MCPB
Item No. 3
Date: 6/14/2018

Clarksburg Premium Outlets at Cabin Branch: Limited Site Plan Amendment 82014016B (In Response to Site Plan Violations)

Staff Report Date: June 1, 2018

Figure 2. Rendered landscape drawing from original site plan (820140160) staff report. The area in red shows the path of Premium Outlets Drive, which begins at Clarksburg Road (MD 121) and terminates near the amphitheater.

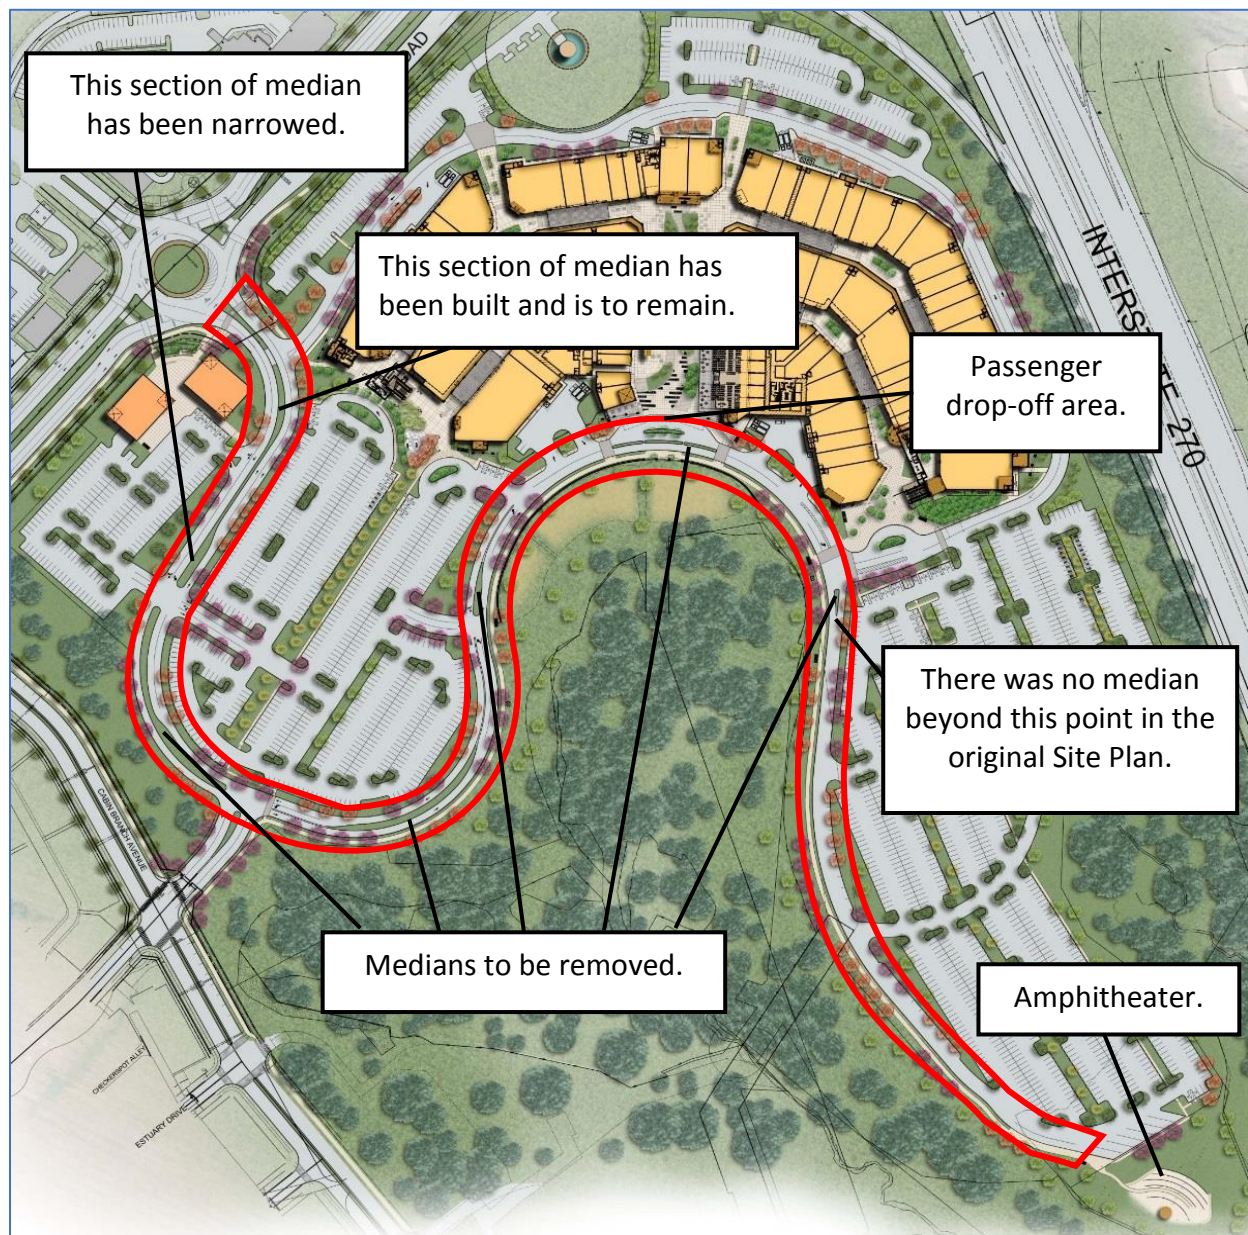
- A median is required for the entire length of the drive aisle, despite the median not being shown throughout the drive aisle's length on the Certified Site Plan. The final $\pm 1,100$ feet, heading towards the amphitheater at the south end of the Property, do not include a median at all.

In Figure 2, a green strip—indicating a planted median—can be seen running in sections down the center of the mall access road from Clarksburg Road until just past the mall, at which point the road continues without a median to its end near the amphitheater.

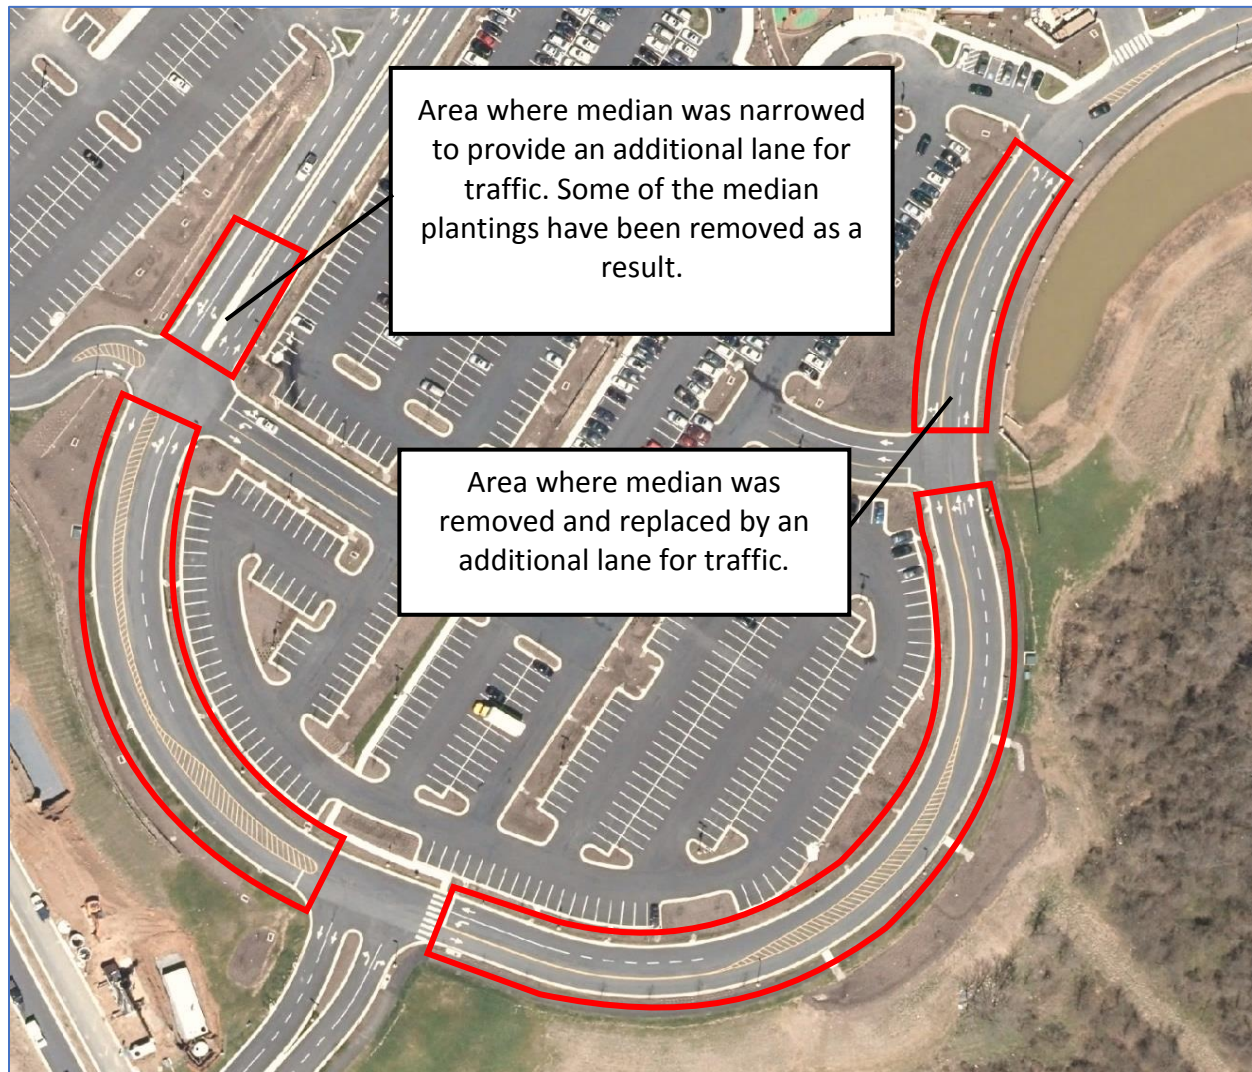
The two images below (Figure 3 and Figure 4) show 2017 aerial images of the completed mall access road. In some places, the raised, planted median has been replaced by yellow striping; in others, it has been replaced by a simple yellow lane marking.

Figure 4. 2017 aerial image showing the second part of the mall access drive. The areas where the raised, planted median has been removed are shown in red.

The Applicant had originally constructed the access aisle with a raised median (Figure 5). However, trucks and vehicles towing trailers were having difficulty navigating the curves along the route without running onto the medians. This is the route buses and delivery trucks use to access the site, so the medians would likely have created problems for these vehicles as well. The Applicant was also concerned about what would happen if a vehicle were to break down in one of the single-lane sections of roadway, especially during a peak shopping day; it would be virtually impossible for cars to pass a disabled vehicle. Because of these concerns, the applicant removed the medians. Plants originally intended for the raised medians were relocated elsewhere on the Property.

The replacement of raised, planted medians with pavement striping and reconfiguration of lanes along the mall access road improves vehicular circulation. As originally designed and installed, the road would have been difficult for buses and trucks to navigate without running onto the medians, and a disabled vehicle would have completely blocked traffic in one direction. The revised access road adequately addresses these issues and is both safe and efficient.

Figure 6. Current and revised Street Types Diagram. The revised diagram shows the mall layout.

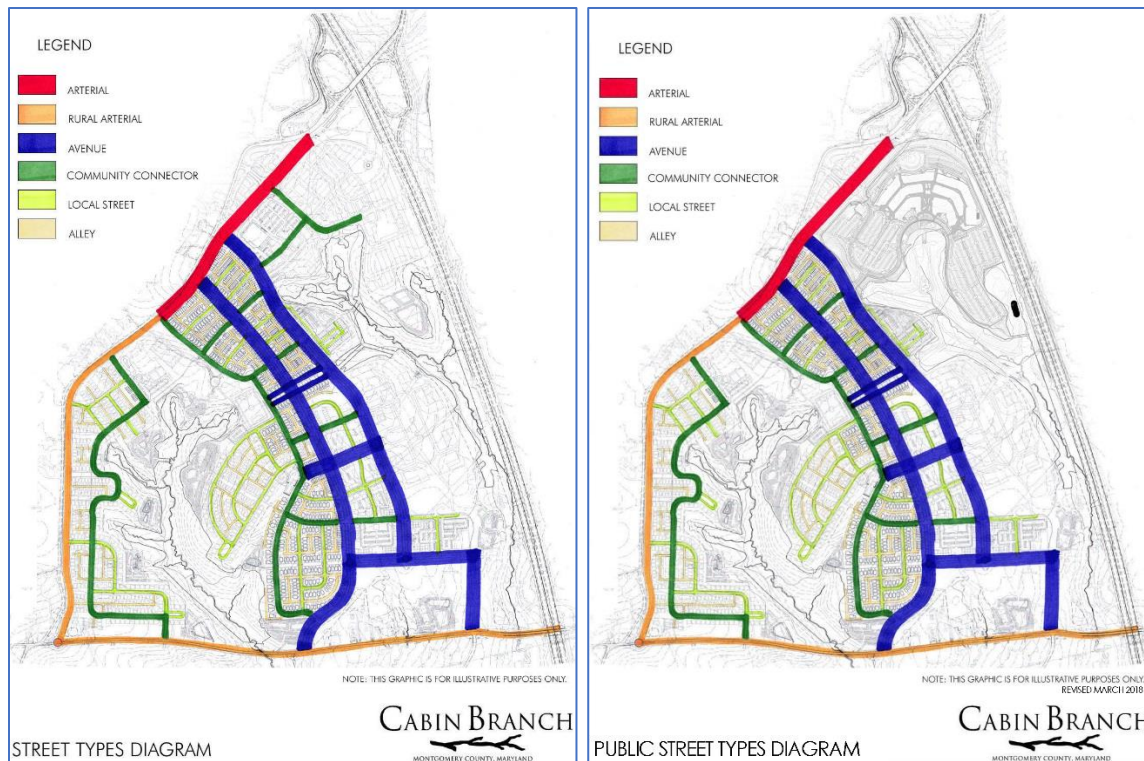
Related to this issue is an update to the *Cabin Branch Design Guidelines for Site Plan Review* ("Design Guidelines"), which were amended with the original Site Plan for the Clarksburg Premium Outlets to incorporate the design features of the new outlet mall. However, the Applicant did not modify the Street Types Diagram to correspond to the new layout, making it difficult to know what type of street profile was desired for the roads in the new layout. The original diagram showed a set of roads in the same area now occupied by the mall access road and parking lots and designated that these roads would be "community connectors," but these roads did not correspond to the location of the mall access road. The Design Guidelines showed both street section illustrations for community connectors as roads with medians. The Applicant has revised the Street Types Diagram to remove any streets in the mall area. The current and revised Street Types Diagrams are shown in Figure 6.

The Street Types Diagram has also been relabeled to clarify that it applies only to public streets and not to private streets, such as the mall access road.

Figure 7. Originally approved playground equipment.

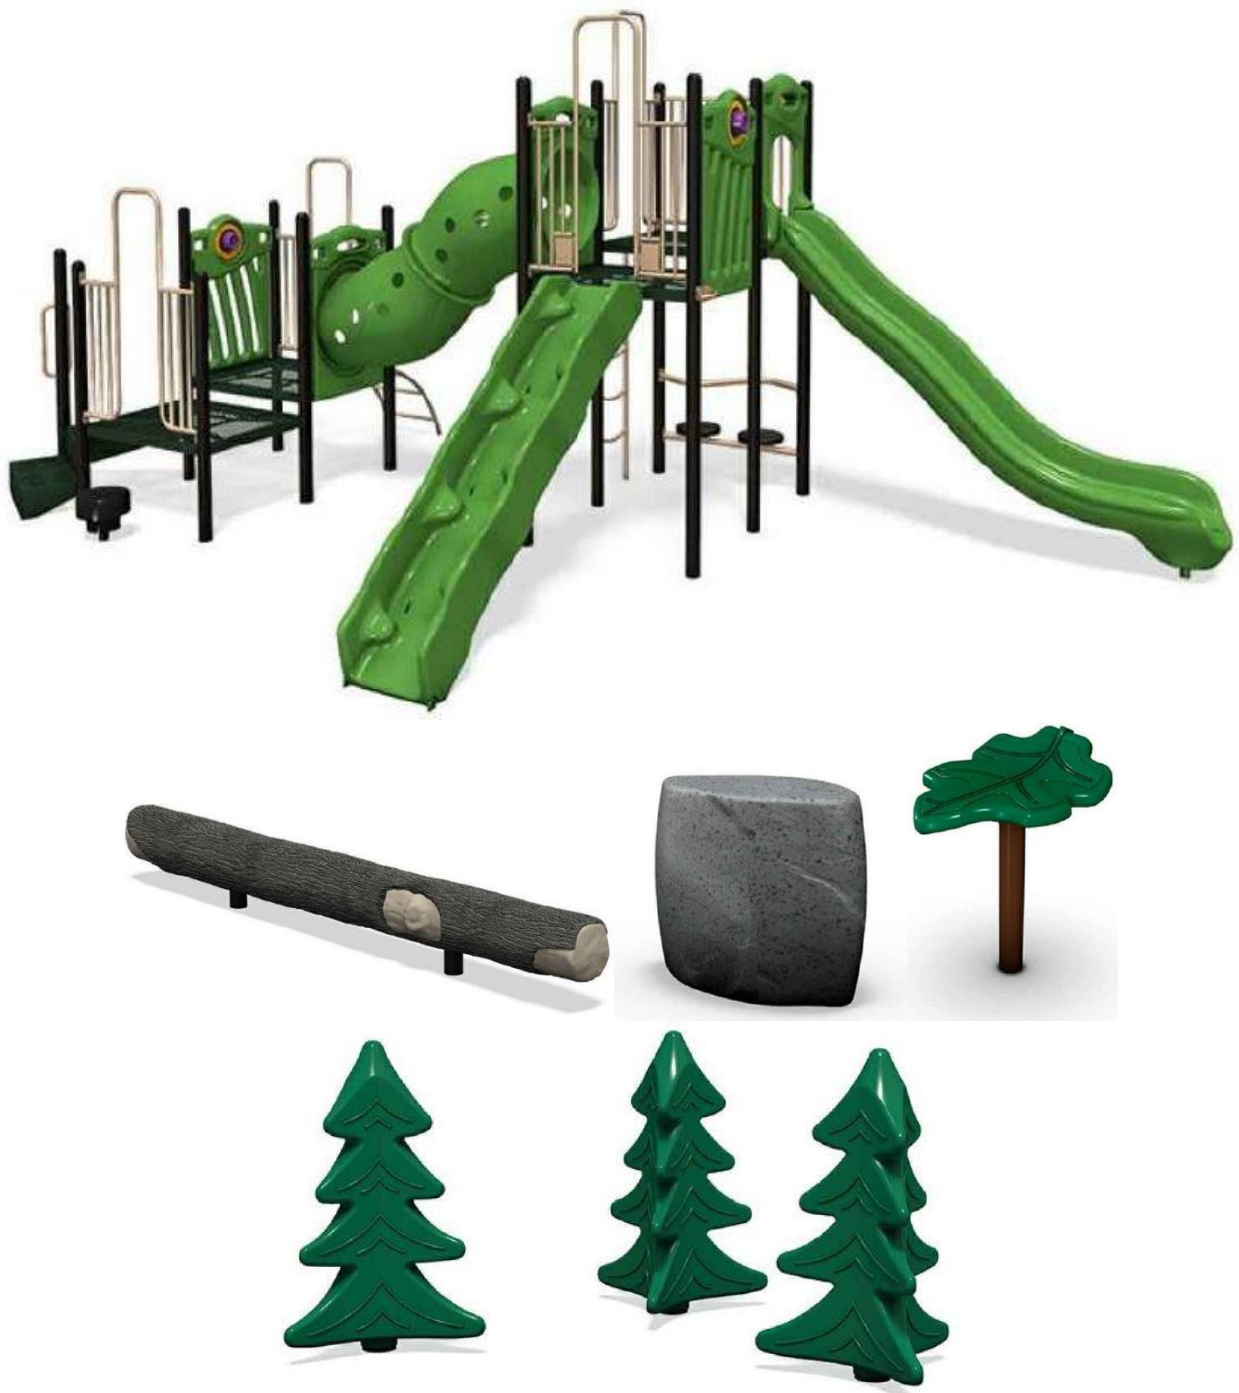
The Applicant has revised the Site Plan to reflect the playground equipment that was built. See Figure 7 for examples of the originally approved equipment and Figure 8 for what was installed.

Figure 8. Proposed/installed playground equipment.

The modifications to the playground equipment and layout are adequate, safe, and efficient as conditioned. Although the equipment is different, it still accommodates a range of activities for similar age-groups of children.

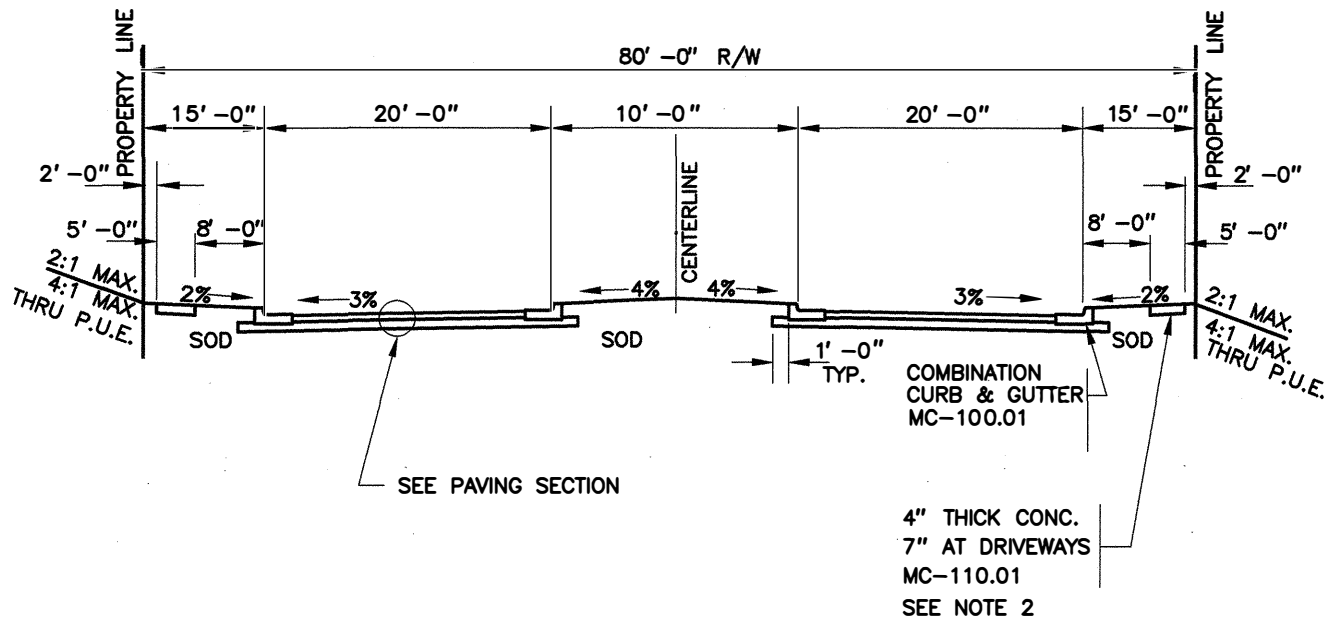
Components of Tot Lot have not been constructed as required by the M-NCPPC Certified Site Plans.

The non-compliance items include but are not limited to the:

1. Play Equipment
2. Playground surfacing
3. Fence
4. Benches
5. Light fixtures.

Corrective action has to be taken by 10.27.2016. by constructing the elements as specified by M-NCPPC Certified Site Plan #820140160/A. Please provide Certifications that the equipment, surfacing and the layout of the playground meets or exceeds all the necessary standards for Playground Equipment for Public Use (ASTM. F 1487, F 2223, F 1292).
